**To:** Members of Dublin City Council  
**From:** Dana L. McDaniel, City Manager   
**Date:** November 2, 2017

**Re:** Ordinance 78-17 – Amending Sections 153.058, 153.059, and 153.062 of the Dublin Codified Ordinances (Zoning Code) to Create the Historic South District and Associated Regulations within the Bridge Street District (Case 17-052ADMC - Historic Dublin Zoning Code Amendment).

**FIGURE 153.062-W: HISTORIC COTTAGE COMMERCIAL BUILDING TYPE DIAGRAM.**

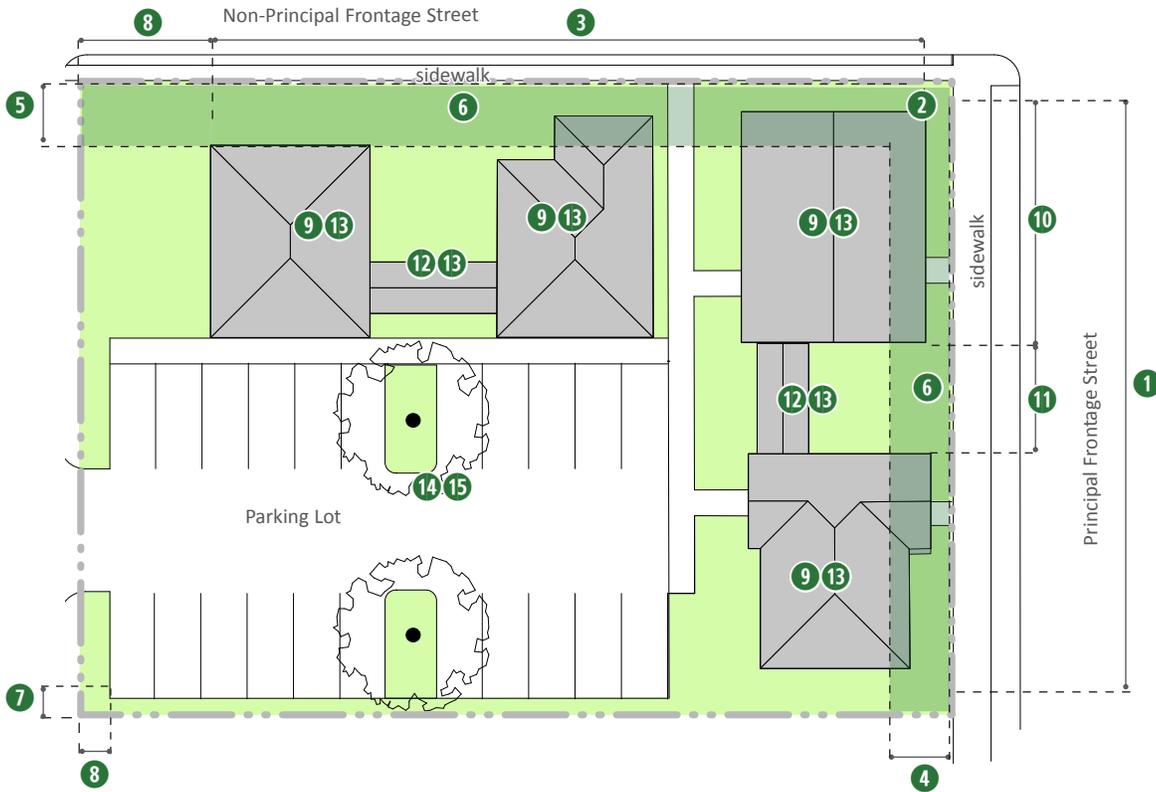
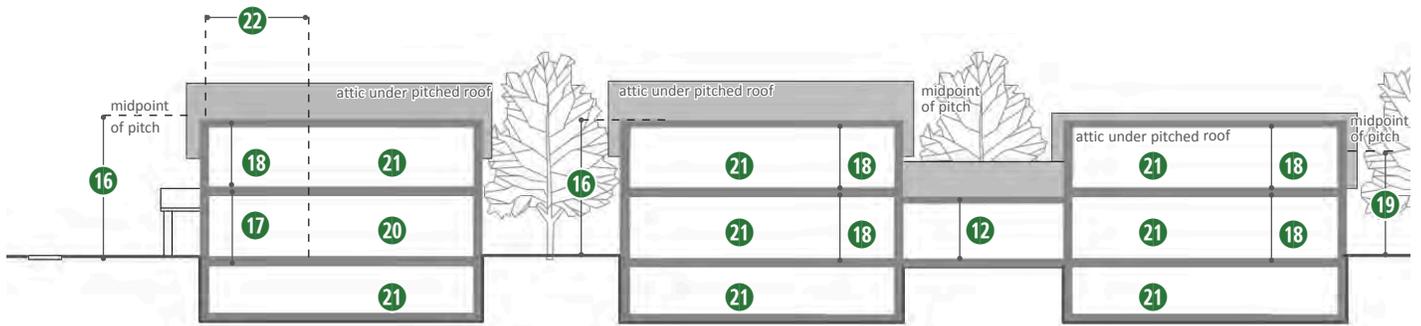
Ms. De Rosa suggested that it would be more helpful to really show that the character is actually going to be maintained by these standards. She said the drawings do not currently depict what she is hearing staff articulate or what she has read in the Code. In fact, she said, just the opposite because it appears dense and out of character as they are not demonstrating a cottage feel.
